Subject: Cabot Reading Site, Reading, Pennsylvania (License No. SMC-1562)
Radiological Assessment and Decommissioning Plan
Rip-Rap Cover Design Modifications

CABOT
Reading, Pennsylvania Slag Pile Site
Revision 3 Replacement Pages Instructions

Revision 3, June, 2005

ST Environmental Professionals, Inc.
June 2005, Rev. 3, Project Number 90C057

FIGURE 1-12
PROPOSED RIP-RAP
COVER LOCATION

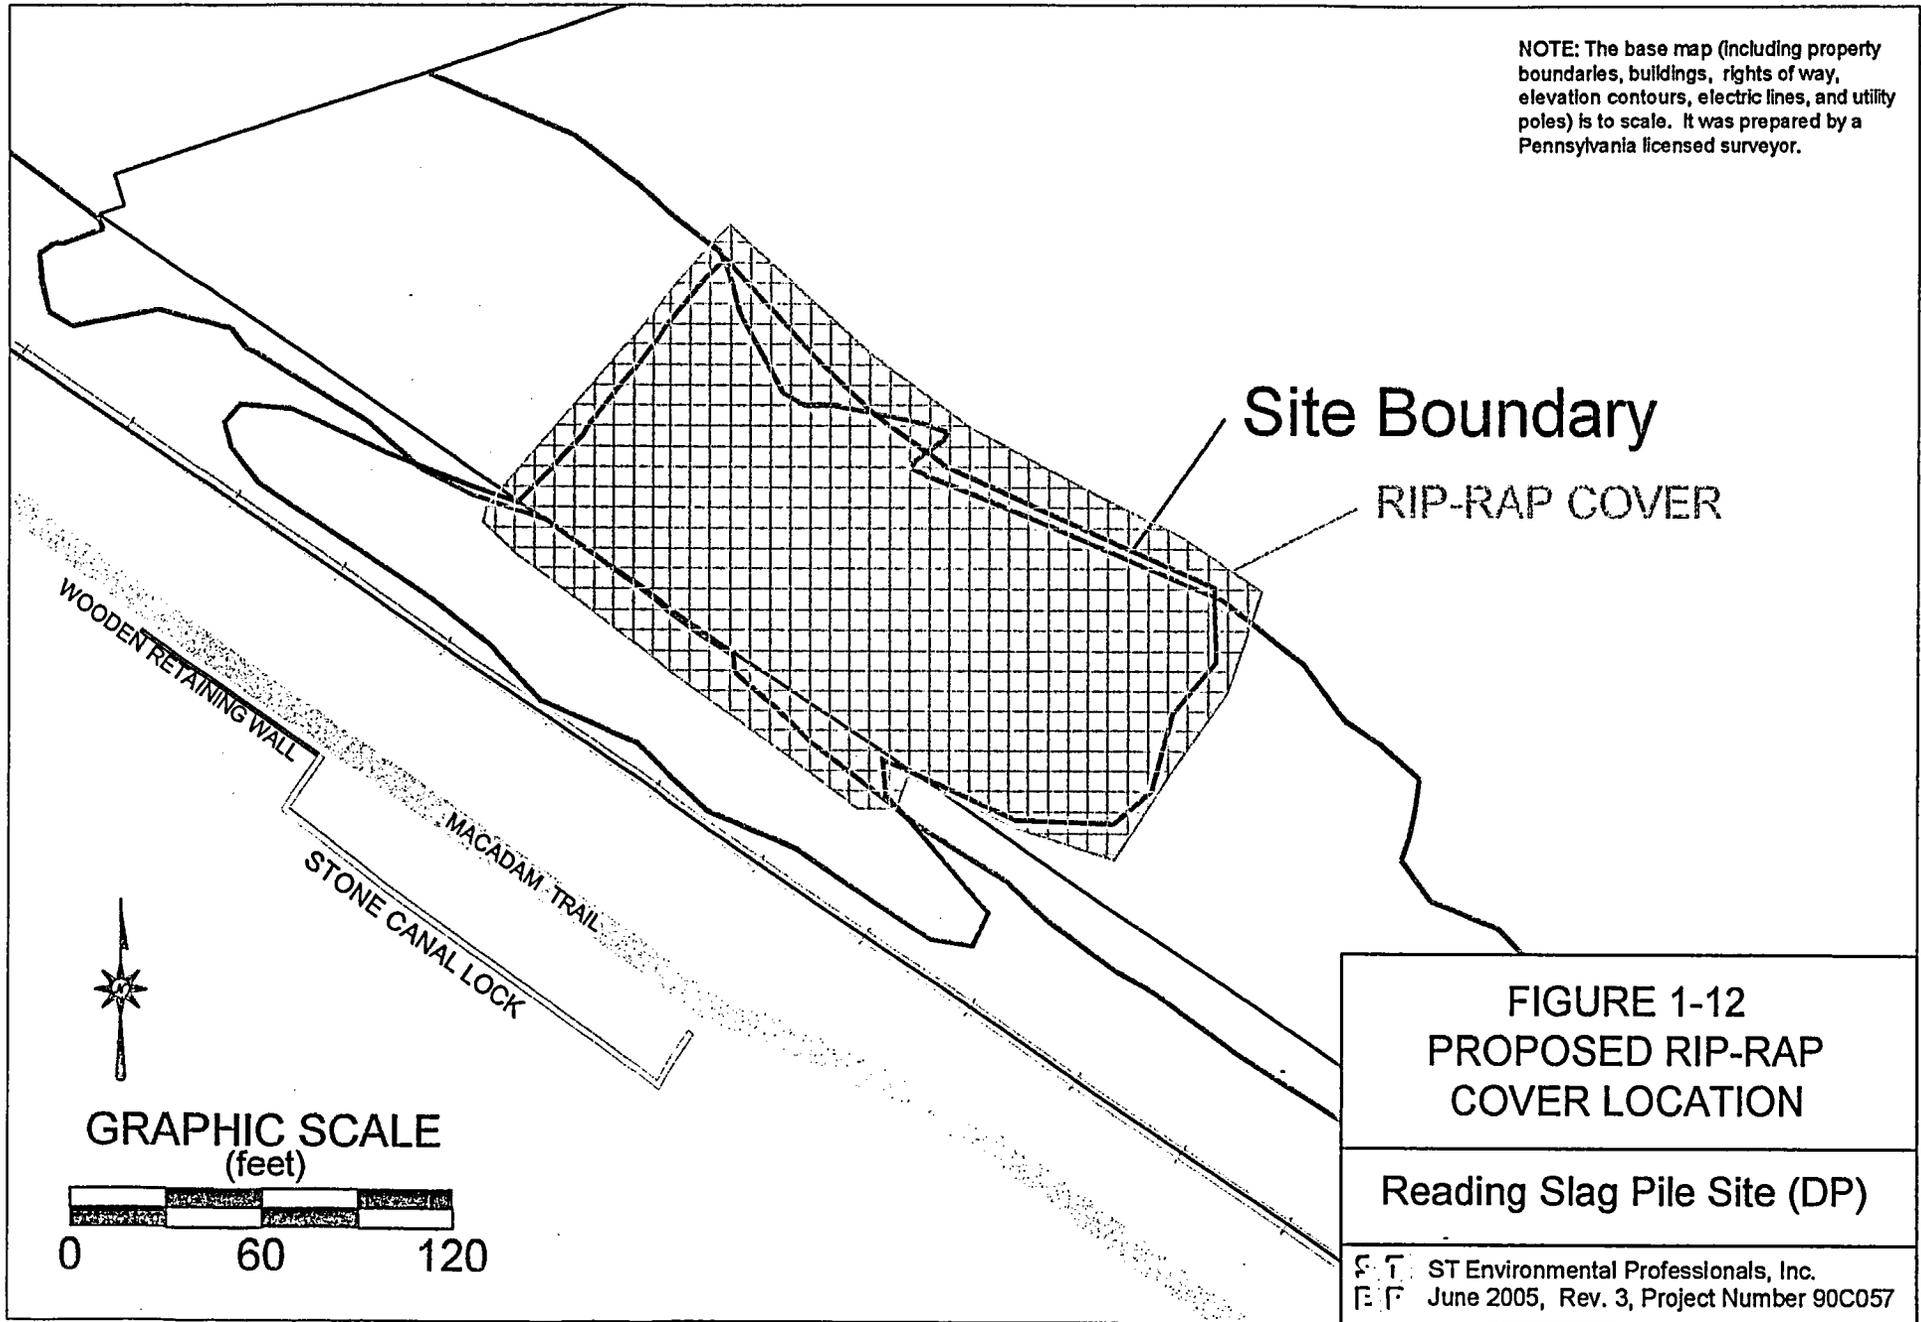
The participants in the meeting concluded that the planned extension of River Road to provide improved access to the Dana property would benefit from a thinner and smaller area of rip-rap in the River Road right-of-way (ROW). To evaluate the feasibility of changing the rip-rap design, Cabot inspected the ACC property. The inspection found that the upper portion of the ACC property drains to the south and east, away from the top of the slope containing the slag. The rip-rap design calculations provided in reference 1 conservatively assumed that the area within 500 feet of the slope drained on to the slag pile. Revised calculations, using the actual topography, resulted in a reduction of the required rip-rap rock size, thickness and width of the rip-rap base extending into the ROW. In addition, the calculations indicated that the rip-rap only needs to extend to the top of the topographic bench in the southern portion of the slope. The revised design, consistent with the calculations, remains compliant with NUREG-1623.

The rip-rap cover design was performed by an experienced geotechnical engineering firm using the guidelines in NUREG-1623. The detailed calculations and procedures for installation are contained in Appendix E. On the slope and top edge of the pile, the cover will consist of a 1.0 foot thick layer of durable rock with an average size of approximately 6" ($D_{50}=6''$). At the base of the slope, a 2.3-foot thick layer of $D_{50}=9''$ durable rock will extend 11 feet from the slope to form a base to anchor the slope. The rip-rap cover is depicted in plan view on Figure 1-12 and cross section in Figures 1-13A and 1-13B.

Following installation of the rip-rap cover the surface elevations of the slag pile will range from approximately 212 feet to 261 feet above MSL, entirely above the 100-year flood level.

FIGURE 1-3
PROPOSED RIP-RAP
COVER LOCATION

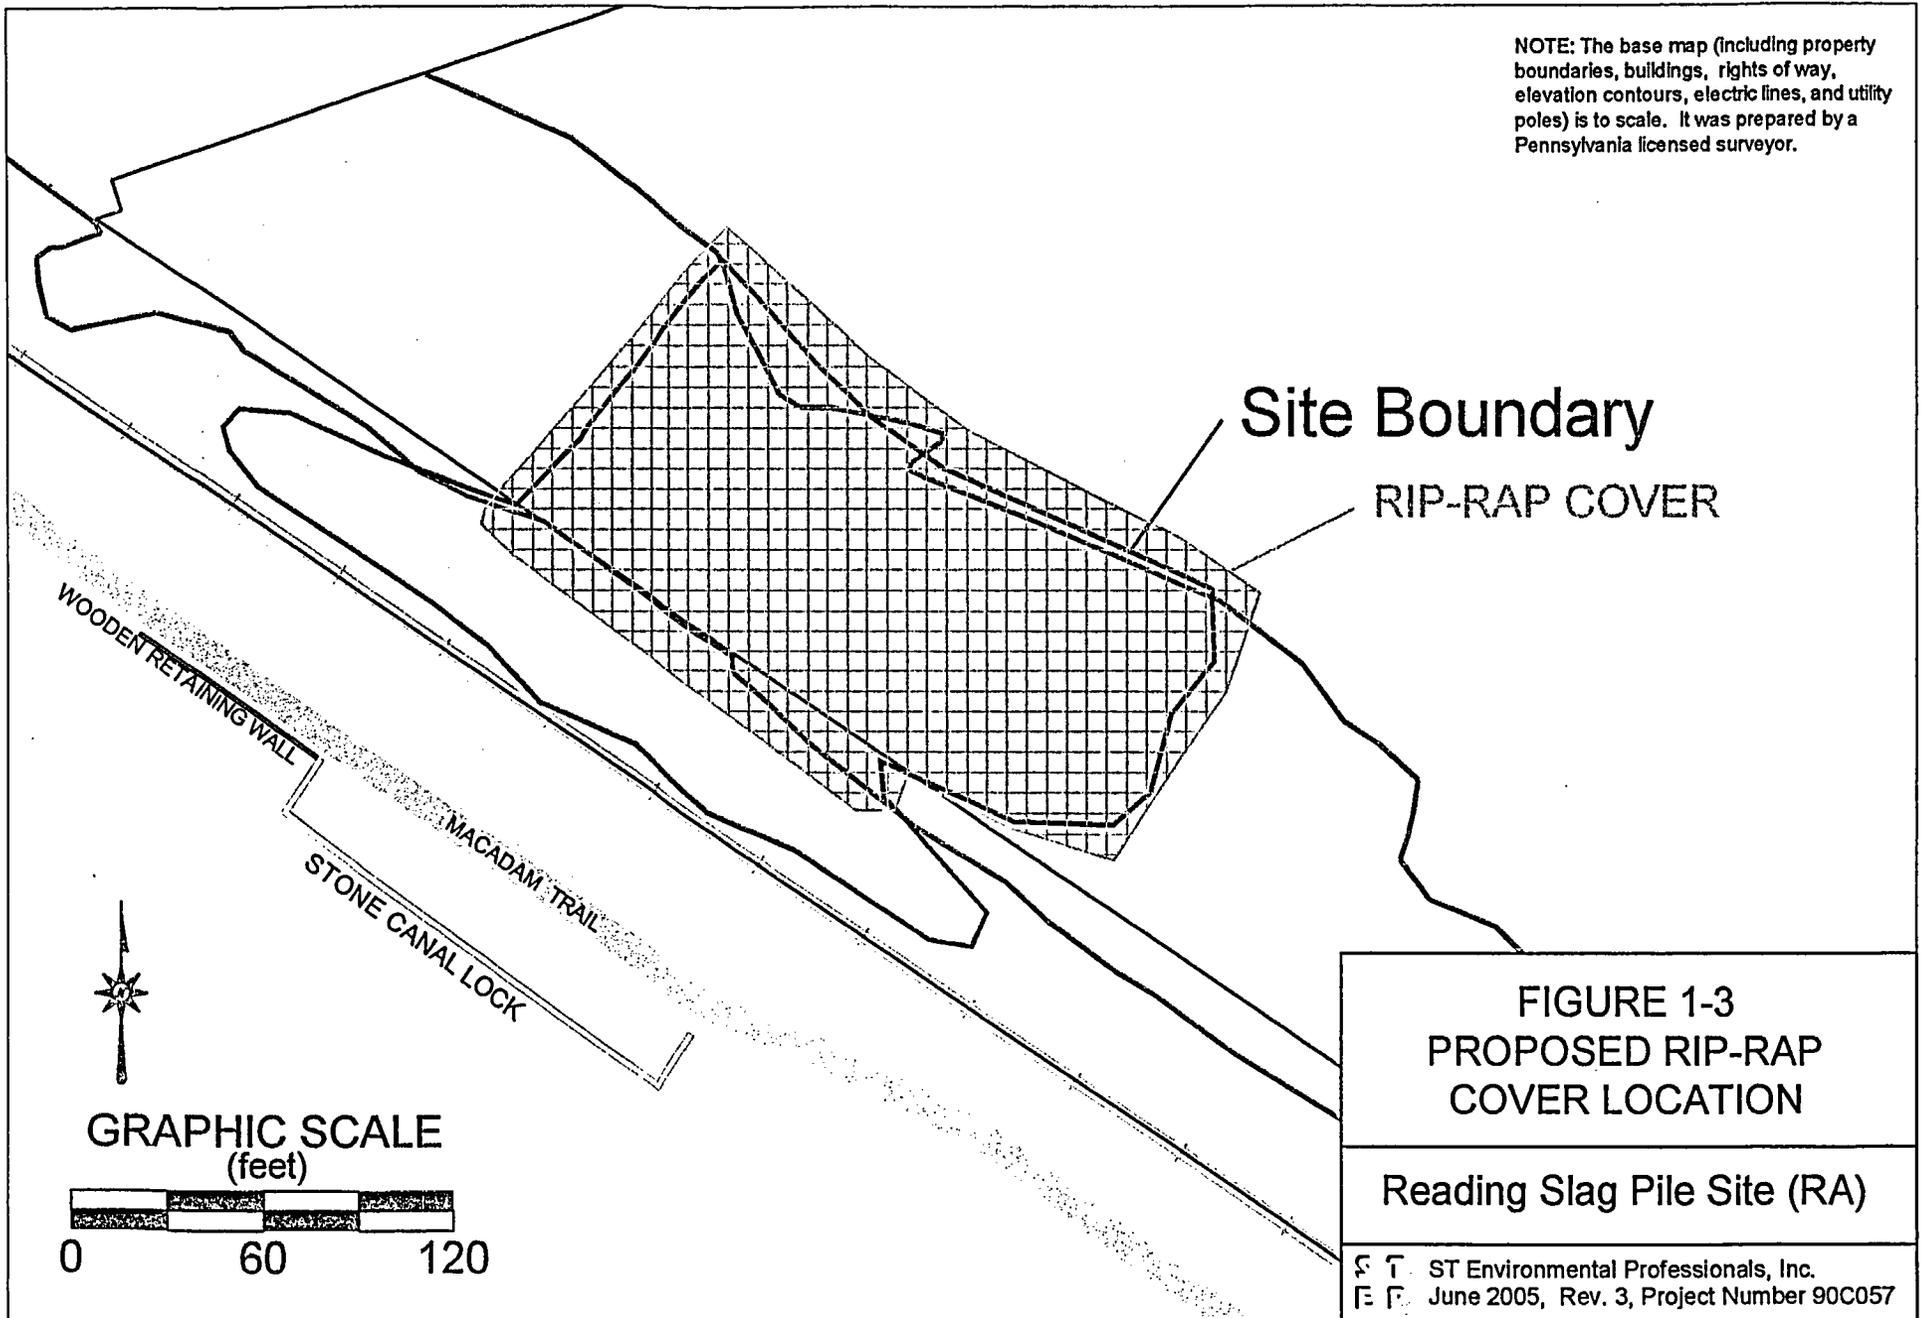
The Decommissioning Plan incorporates emplacement of 1.0-foot thick layer of rip-rap, on the slag pile slope face and along the top edge. A 2.3-foot thick rip-rap apron will extend 11 feet from the bottom of the slope into the River Road ROW to anchor the slope. The rip-rap is intended primarily for added assurance that erosion will not occur over the period of interest. Given this limited purpose and the self-armoring properties of such measures, this feature constitutes a passive engineered barrier, as described in NRC guidance (USNRC, 2003b, Section 3.5). The rip-rap cover is designed to remain effective for erosion control for 1,000 years without maintenance. Consequently, no institutional controls will be required after license termination.

FIGURE 3-2
TYPICAL CROSS SECTION
OF RIP-RAP COVER

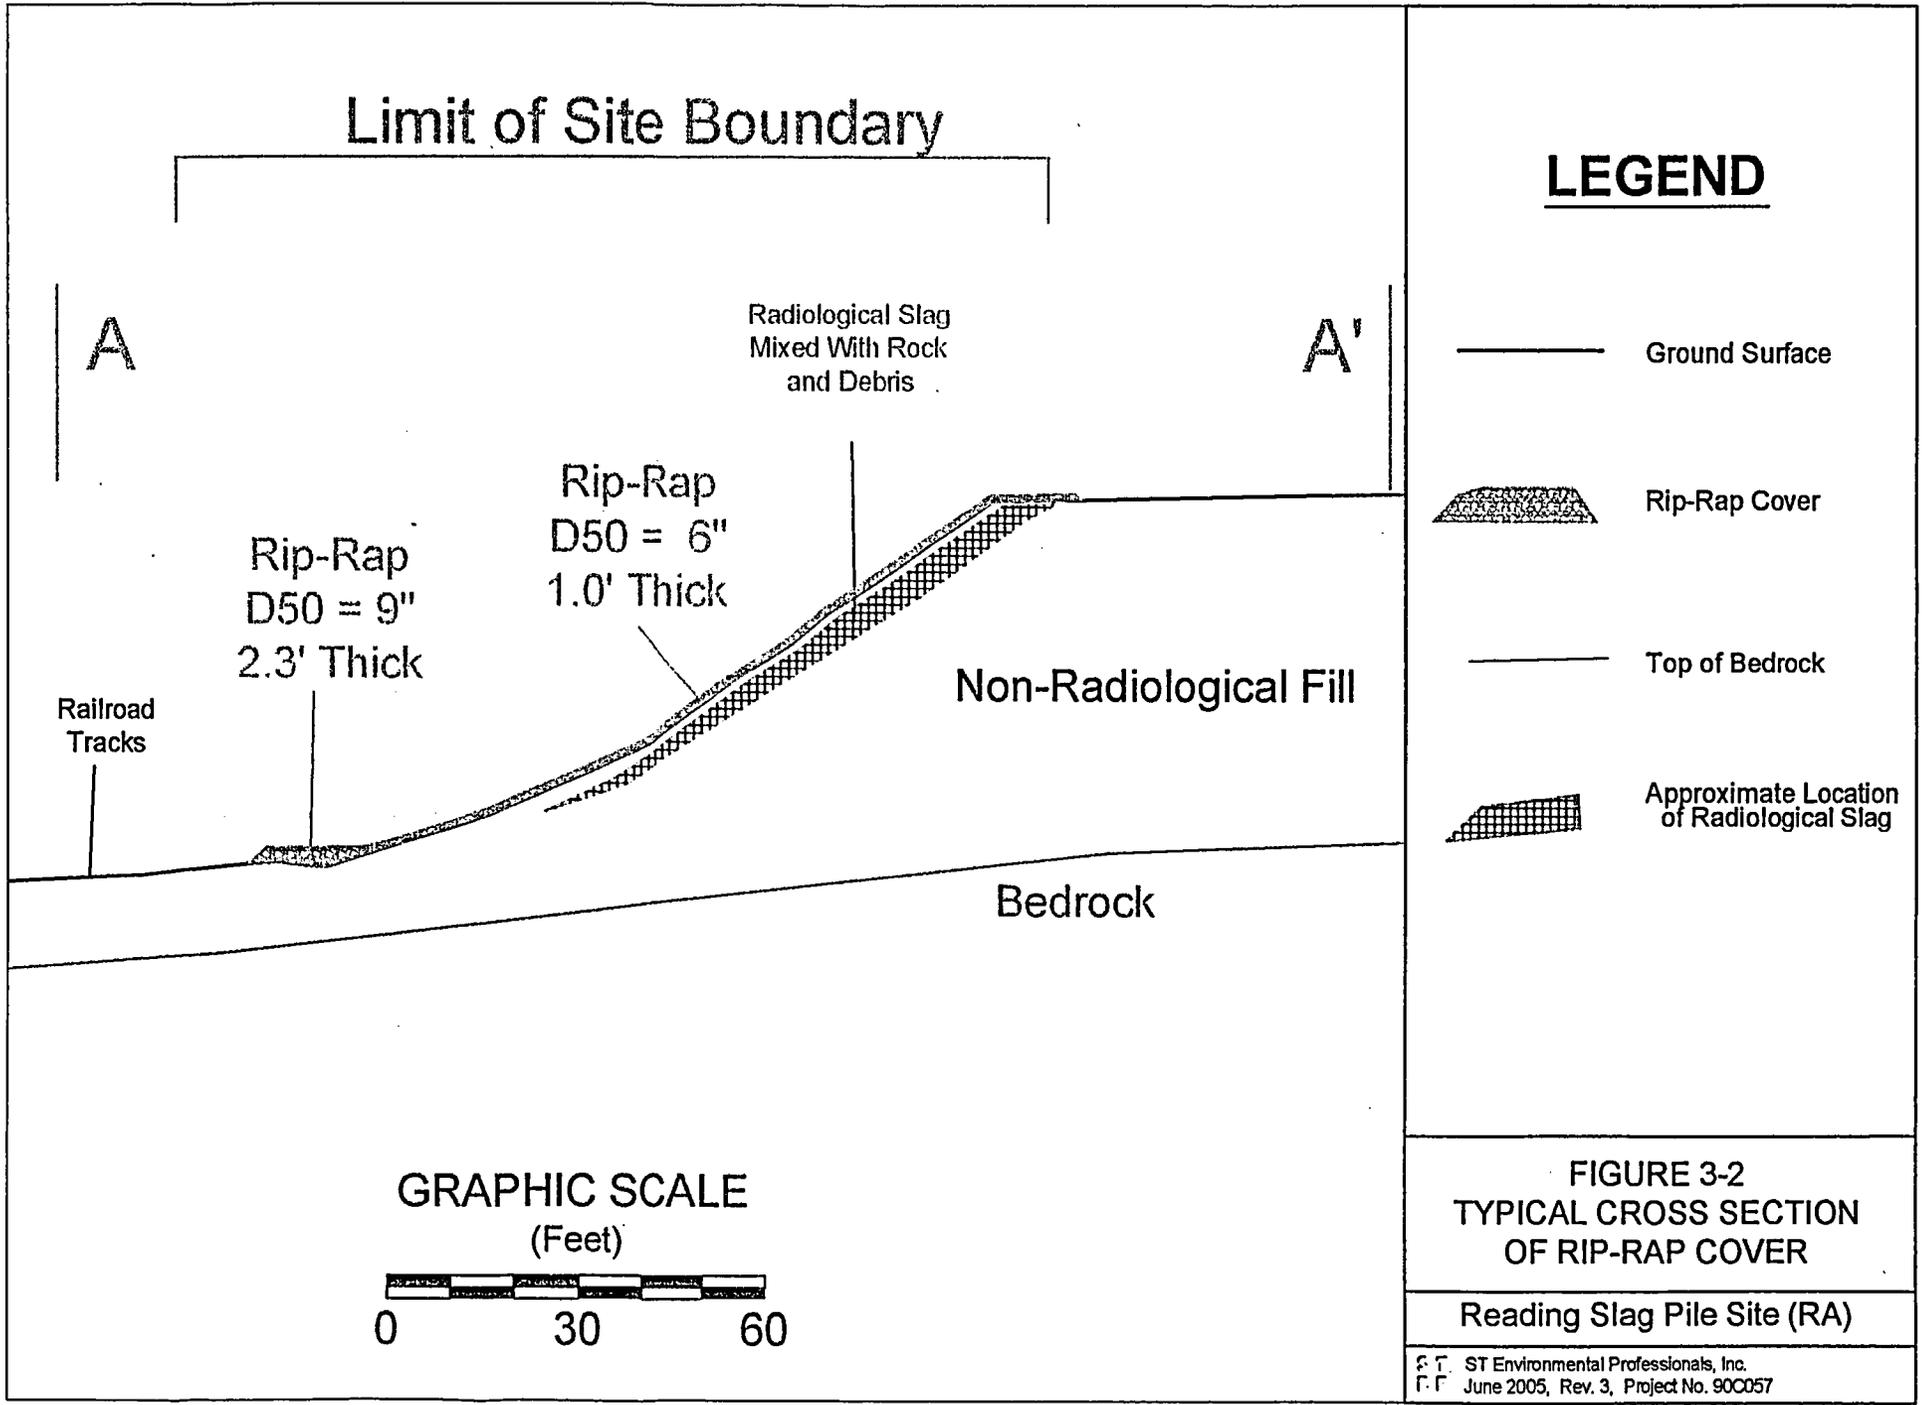
The rip-rap cover on the slope and top edge will consist of a 1.0 foot thick layer of durable rock sized $D_{50}=6''$ (USA number R-4 rip-rap). This exceeds the size criteria calculated using NUREG-1623 methods of $D_{50} = 1.3$ for the slope. An apron of rip-rap will be placed extending 11 feet out from the toe of the slope to anchor the rip-rap cover. This will eliminate the need to excavate slag at the toe of the slope. The apron will consist of USA number R-5 rip-rap ($D_{50} = 9''$). This exceeds the design calculation of $D_{50} = 7.2''$. The apron will be 2.3-foot thick to facilitate proper placement of the large size rip-rap. Additional design details are provided in the Decommissioning Plan (STEP, 2005). Figure 1-3 depicts the location and extent of the proposed rip-rap cover. Figure 3-2 depicts the typical cross section.

Rip-Rap
D50 = 6"
1.0' Thick

Rip-Rap
D50 = 9"
2.3' Thick
